Groundwater Transfer Review Summary Form

Transfer/PA # T- 14600

Ground Water Review Form:

Application: T-14600

Transfer Map

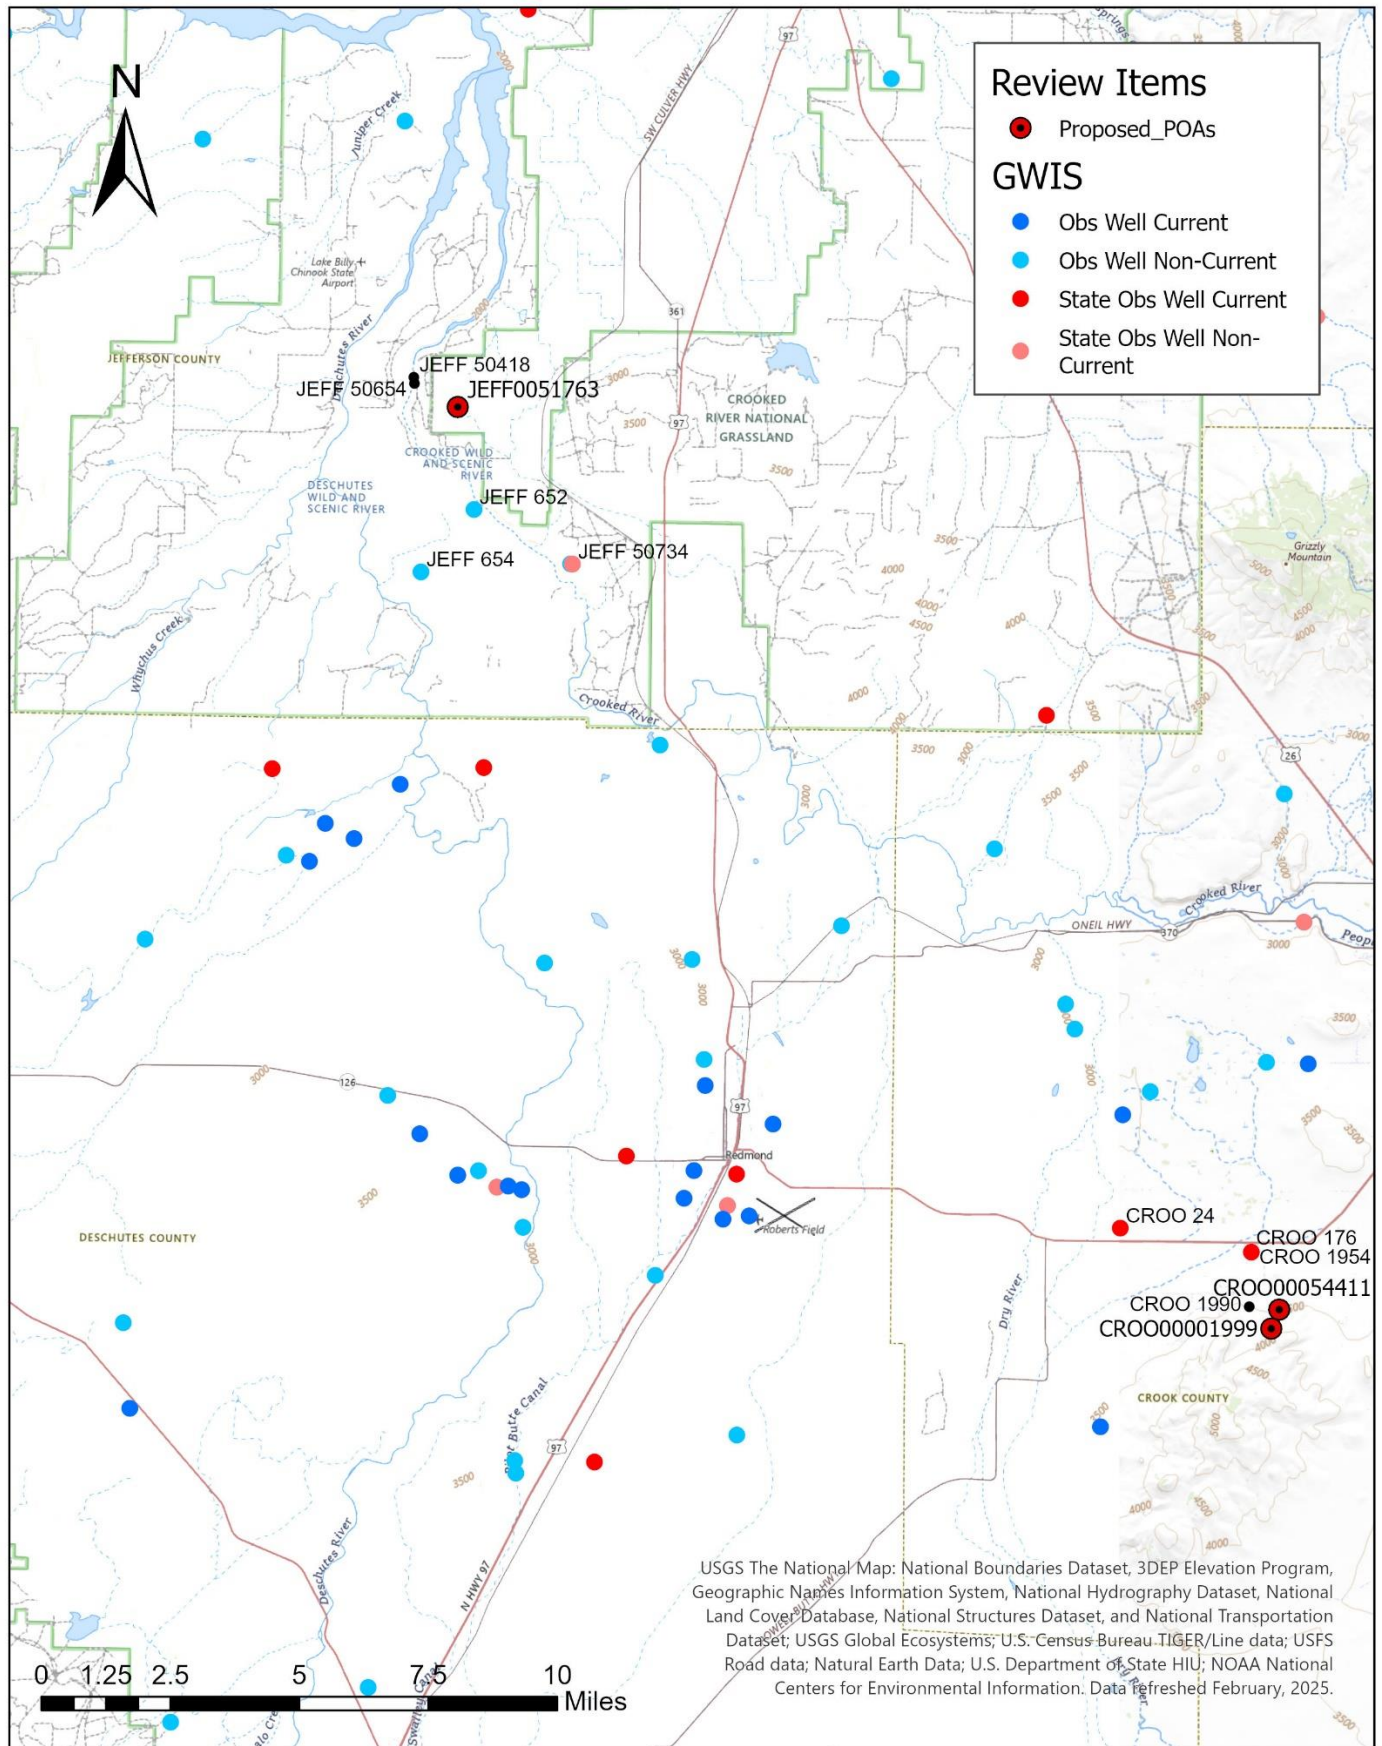
2. Will the proposed POA develop the same aquifer (source) as the existing authorized POA?
☐ Yes ☒ No Comments: "From" wells CROO 54411 and CROO 1999 access an aquifer hosted within the low-yielding silicic bedrock of Powell Buttes (considered part of the John Day Formation). These aquifers are recharged from precipitation falling directly onto Powell Buttes (Gannett, 1987). Groundwater levels in CROO 1999 and CROO 54411 are ~3700 feet amsl and 3300 feet amsl respectively. This is several hundred feet higher than the regional groundwater system hosted in the Deschutes Formation, which sits at approximately 2700 feet AMSL adjacent to Powell Buttes (see CROO 24). In summary, the "from" wells produce from an aquifer system hosted in geological material that is distinct from the Deschutes Formation, receives local recharge from Powell Buttes, and has higher groundwater levels than the regional groundwater system hosted in the Deschutes Formation.

The "To" well JEFF 51763 is located 24 miles to the NW of the "From" wells. It accesses the Deschutes regional aquifer hosted in the Deschutes Formation adjacent to where this aquifer discharges to the Deschutes and Crooked rivers in the "confluence area". Water level elevation in this well is approximately 2075 ft amsl, which is commensurate with the wells drilled adjacent to Opal Springs (JEFF 50418, JEFF 50654, and JEFF 50263). The ultimate source of this aquifer is precipitation in the Cascades to the southwest. **The "From" wells and the "to" wells access distinct aquifers with different recharge sources, so they are considered not the same source.**

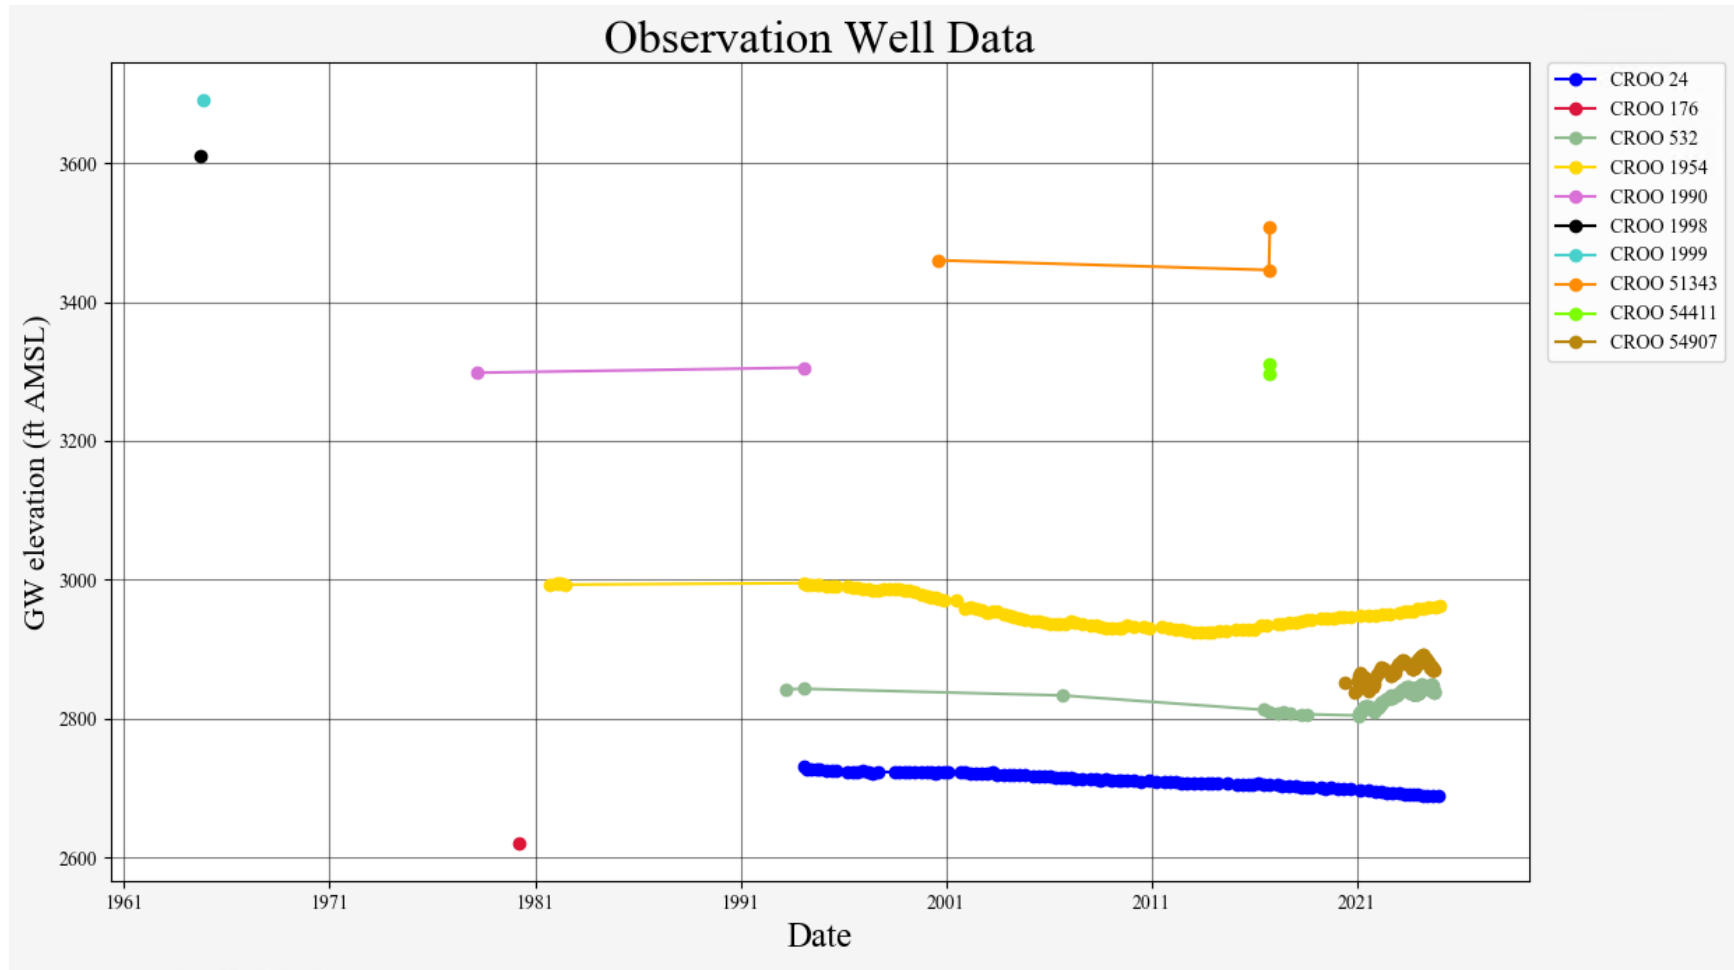
Hydrograph 1: CROO 1954 is an OWRD observation well drilled into the fractured rock aquifer of Powell Buttes. CROO 24 accesses the Deschutes regional aquifer 3.5 miles SW of the “From” Wells. CROO 532 and CROO 54907 show the impacts of the Prineville ASR program in a distal portion of the Deschutes Formation. The “From” wells have a much higher head and likely a different trend than the adjacent Deschutes regional aquifer.

Well Log Summary Statistics for TRS 15S/15E- sections 31 and 32

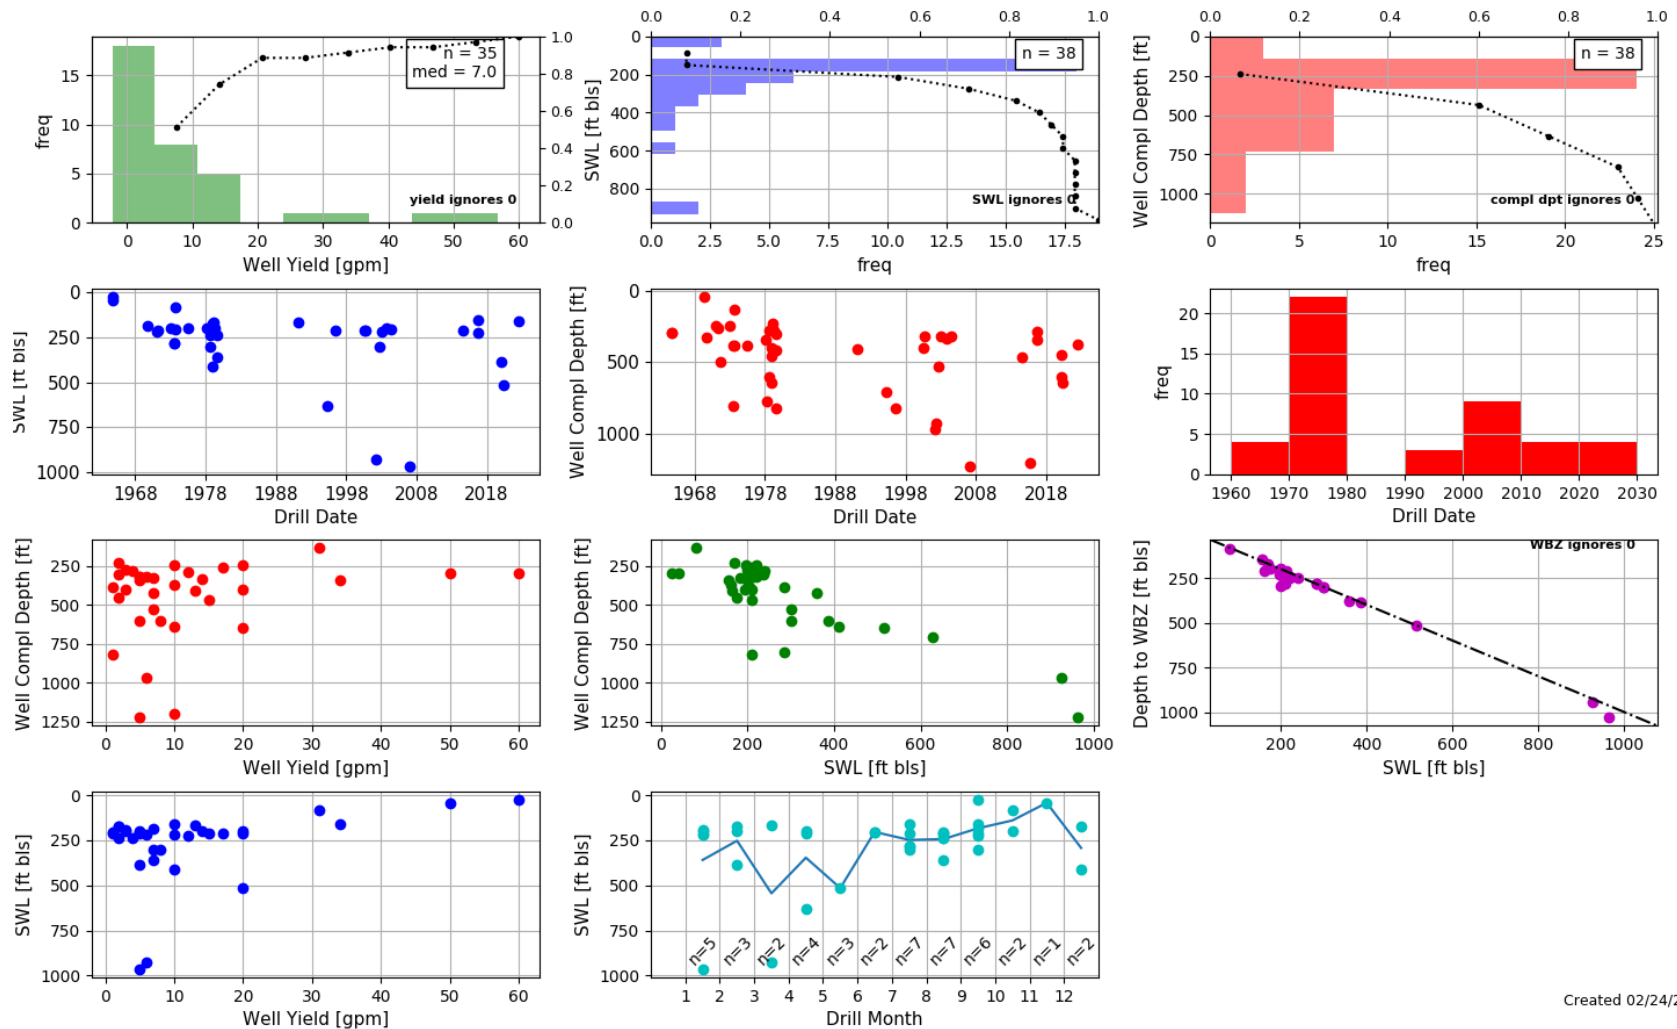
8. What conditions or other changes in the application are necessary to address any potential issues identified above: _____
9. Any additional comments: The figure of summary statistics of well logs near the 'From' wells indicates a median yield of 7 gpm and a max yield of 60 gpm. CROO 54411 indicates a yield of 34 gpm. CROO 1999 indicates a yield of 50 gpm. These well log statistics, the 45-gpm rate in the pump test for permit G-18016, and the low-transmissivity, low storage fractured rock hydrogeologic setting are notable in comparison to the maximum certificated rates of 0.83 cfs (372 gpm) and 0.66 cfs (296 gpm) claimed on the water right. This parallels the comments in the Watermaster Review for this transfer.
